Update Project Proposal: SFF-TA-1016

Presented: August 16, 2024

Project Proposal: SFF-TA-1016, new updates to Rev 1.2

Figure 7-3 Low Profile Vertical Receptacle Connector Mate to the Hybrid E1 Plugs

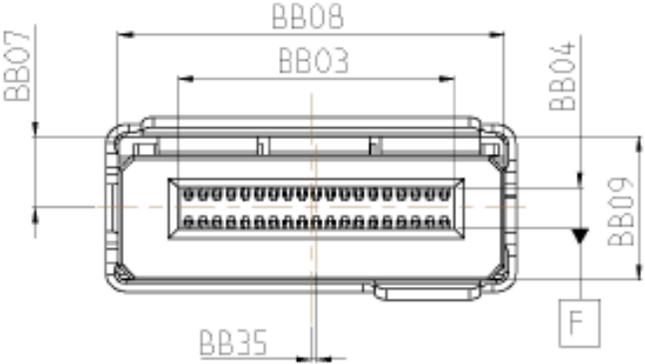
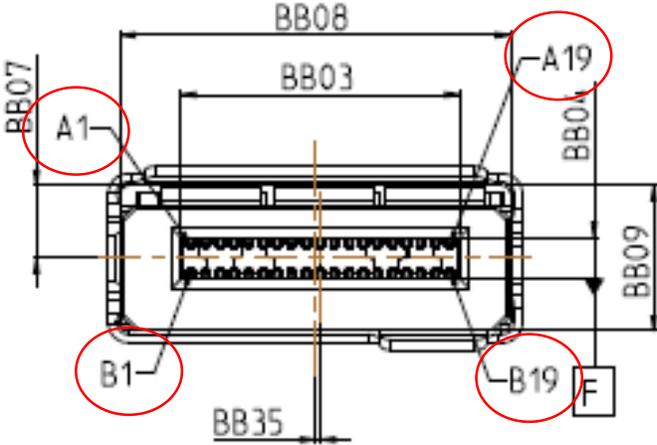
Page. 59 added pin A/B row

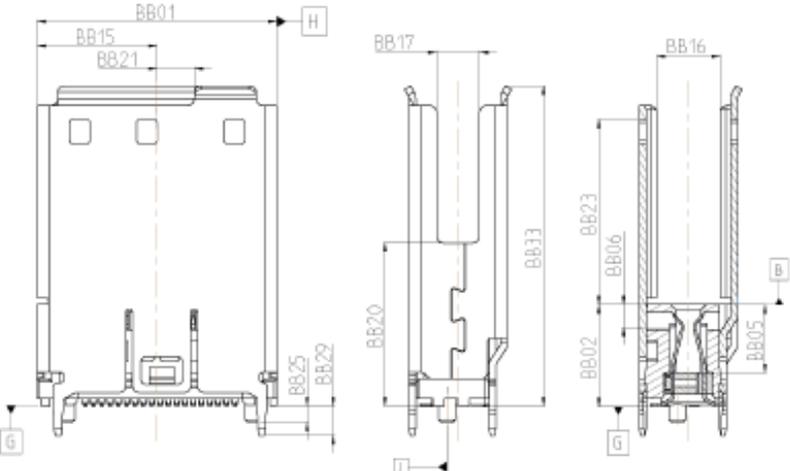
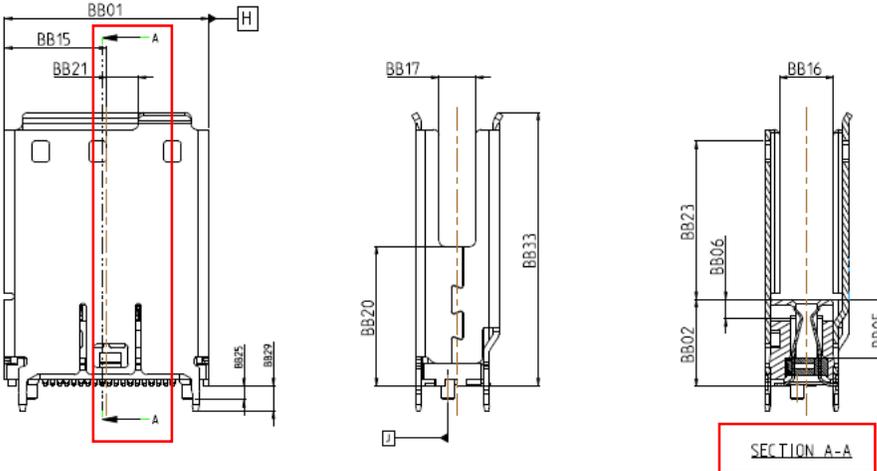
Page. 59 added section A-A position and description

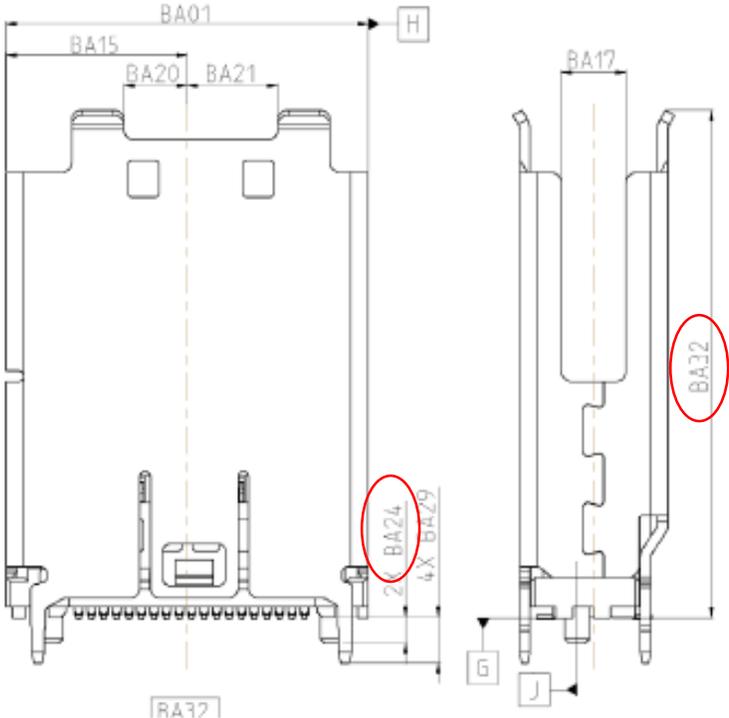
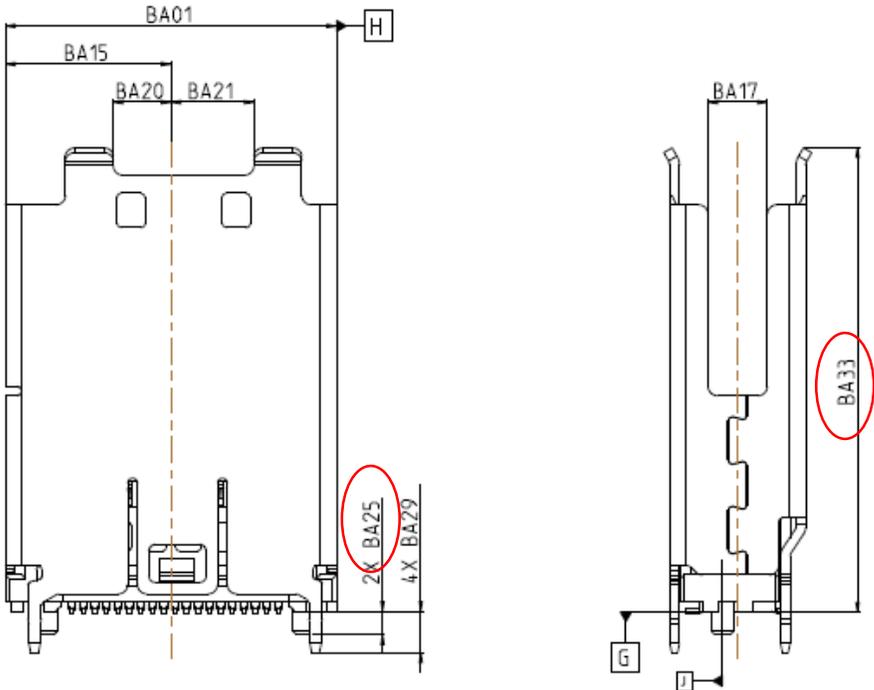
Page. 65 corrected dimension#

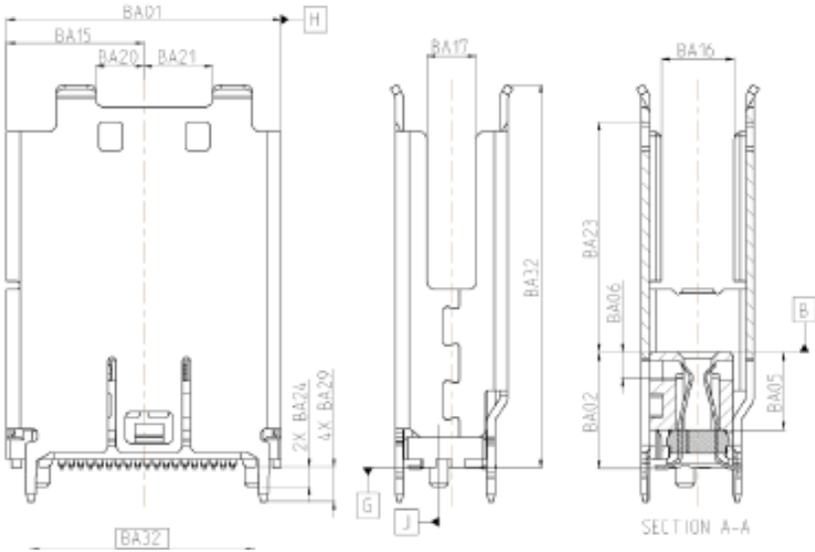
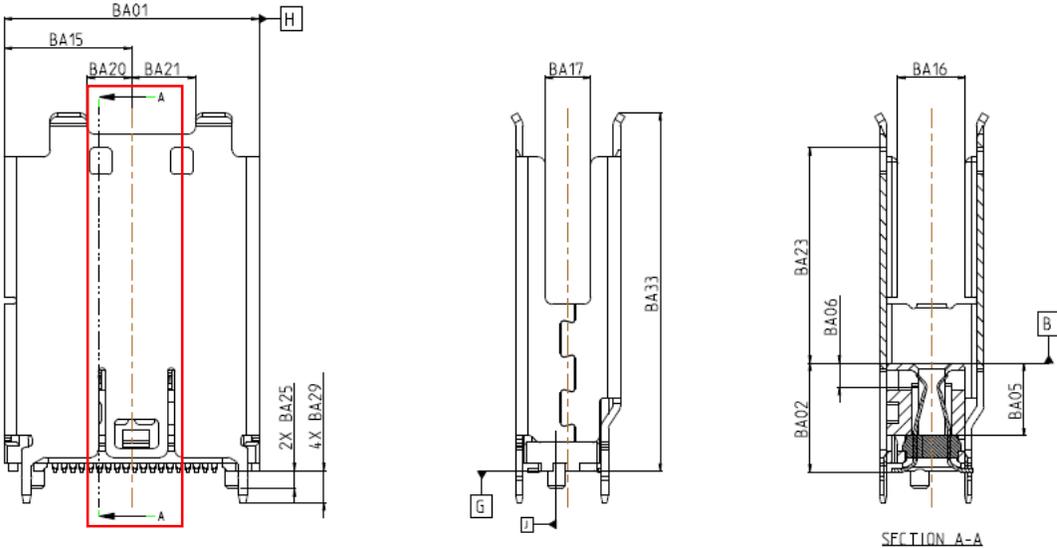
Page. 65 added section A-A position

Figure A-5 Recommended Footprint for Hybrid EDSFF E1/E3 Vertical 38P Connectors

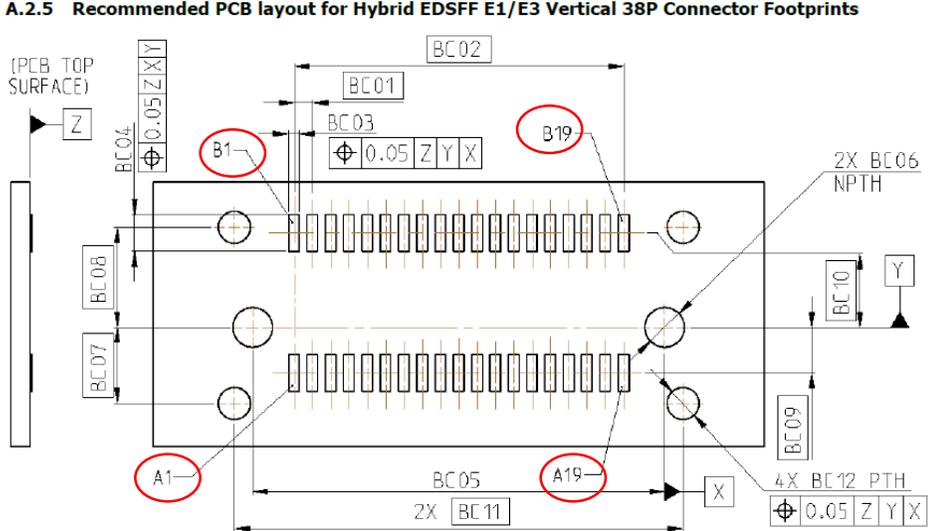
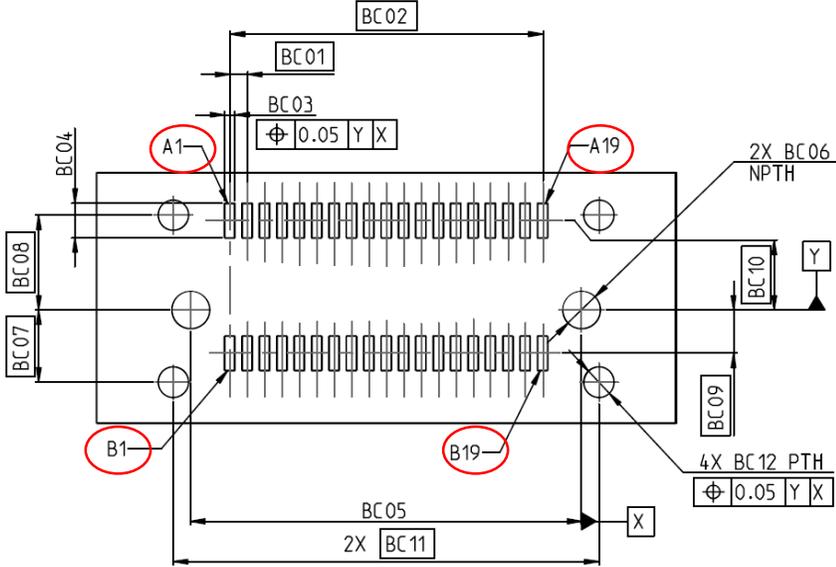
Page. 77 corrected pin A/B row
